STATE OF CONNECTICUT
DEPARTMENT OF TRANSPORTATION

subject: New Bridge Design Standard
Practice

m e m o r a n d u m

date: July 6, 2005

**PARAFFIN COATED JOINTS
IN SIDEWALK PARAPETS**

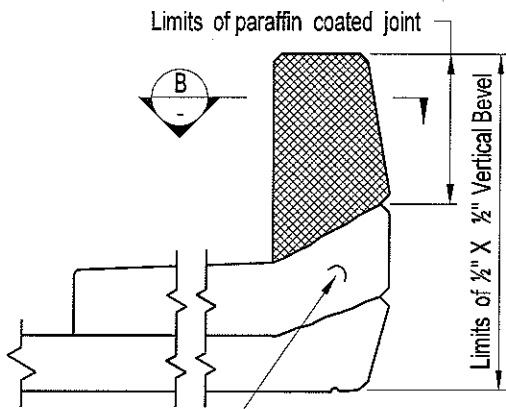
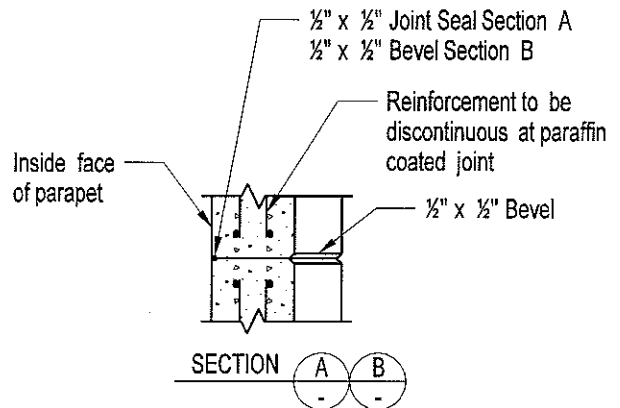
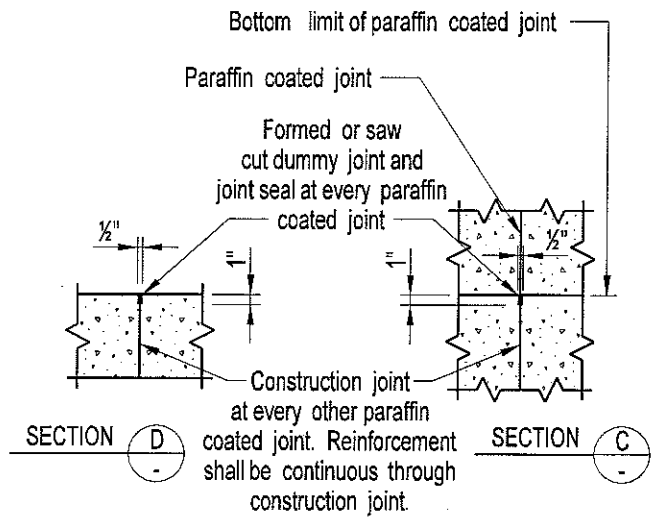
Paraffin Coated Joints - Random Parapet cracking associated with shrinkage has been noticed as a result of eliminating paraffin coated joints.

Reintroduce paraffin coated joints in bridge parapets to control the location of the shrinkage cracks.

For design information, see Plate 6.2.9

**JOINTS IN PARAPETS AT TRANSVERSE
DECK CONSTRUCTION JOINTS**

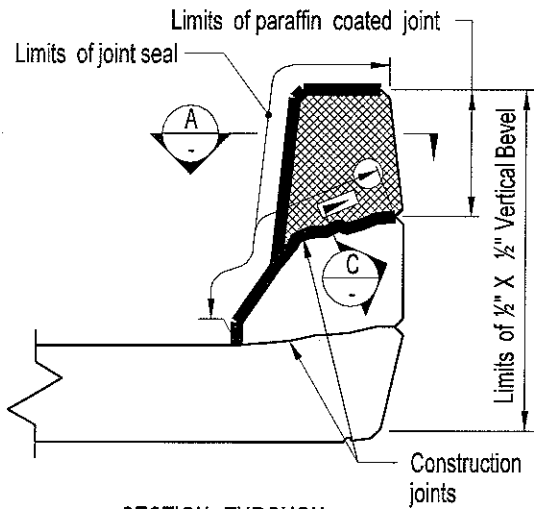
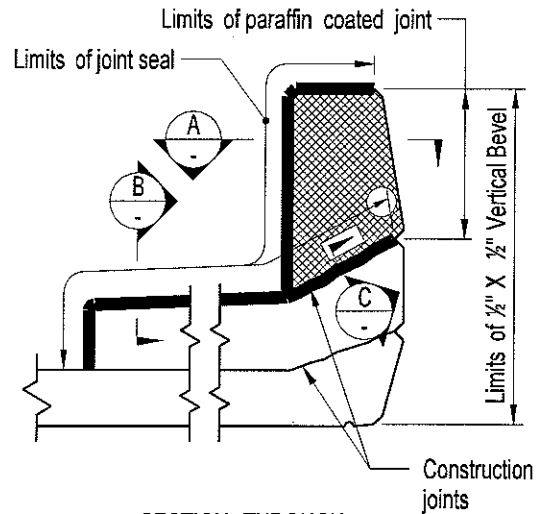
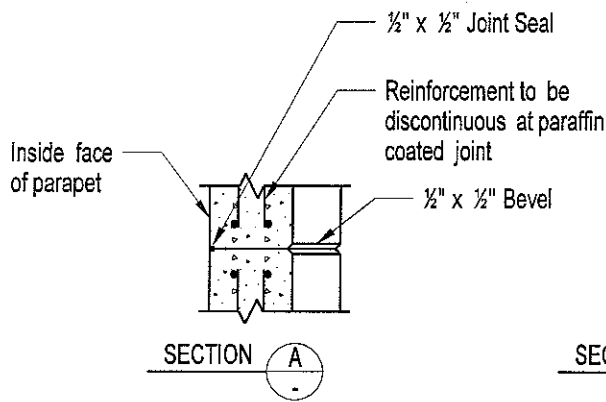
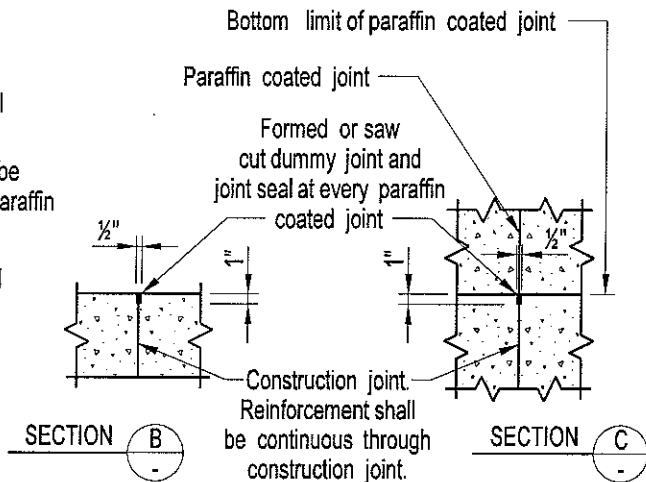
Construction joints and paraffin coated joints shall be placed in the standard parapet, sidewalk and sidewalk parapet coinciding with the transverse deck construction joints. The placement of railing posts, fence posts and additional paraffin coated joints shall take into consideration the location of the transverse deck construction joints.

**PARAFFIN COATED JOINTS
IN STANDARD PARAPETS**

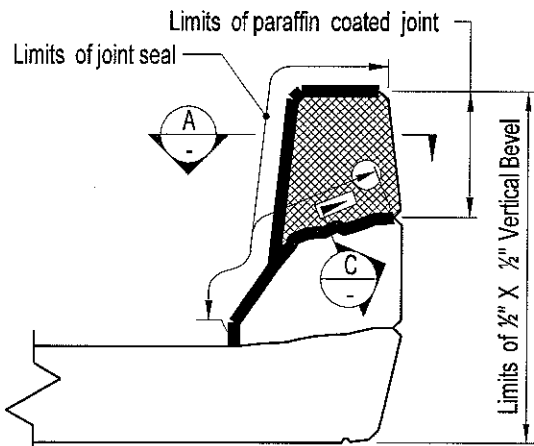
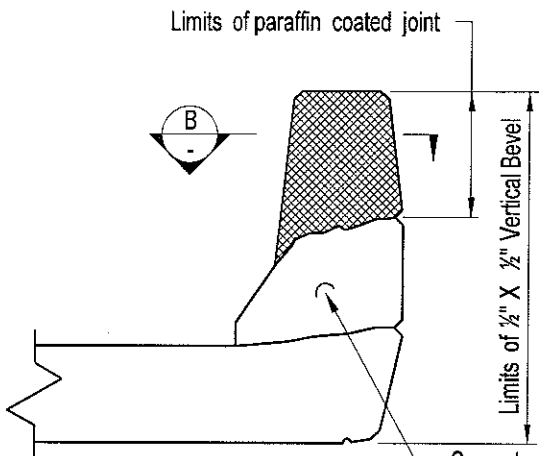
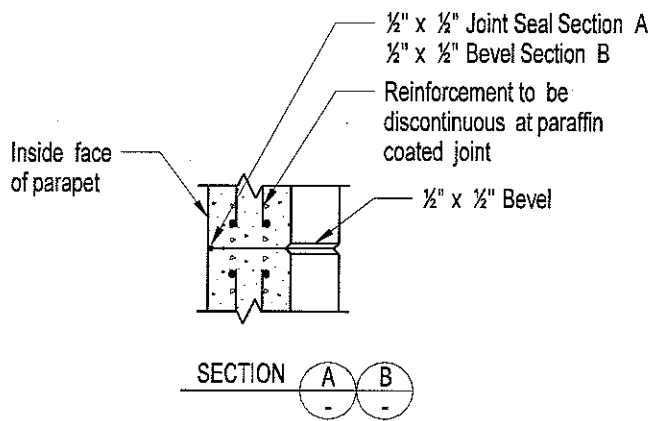
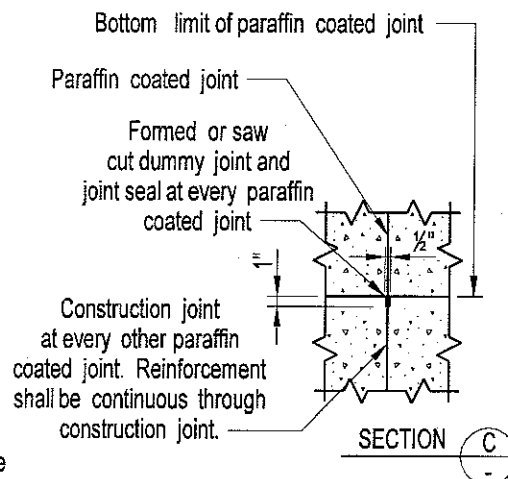
All parapets supported by decks or butted prestressed deck units shall have paraffin coated joints. The paraffin coated joint spacing shall be shown on the plans. The paraffin coated joint spacing shall be based on the total parapet length, location of deck joints, location of transverse deck construction joints, railing and fence post spacing. The paraffin coated joint spacing shall be as follows:

In positive moment regions: 8'-0" <= joint spacing >= 20'-0"
In negative moment regions: 8'-0" <= joint spacing >= 10'-0"

For parapets that support a railing or fence, the joint spacing shall be a multiple of the railing or fence post spacing and the joints shall be located in the middle of the railing or fence panel. Preferably, the number of joints should be minimized so as to expedite the parapet construction. Paraffin coated joints are not required in U-Type wingwalls and parapet walls.
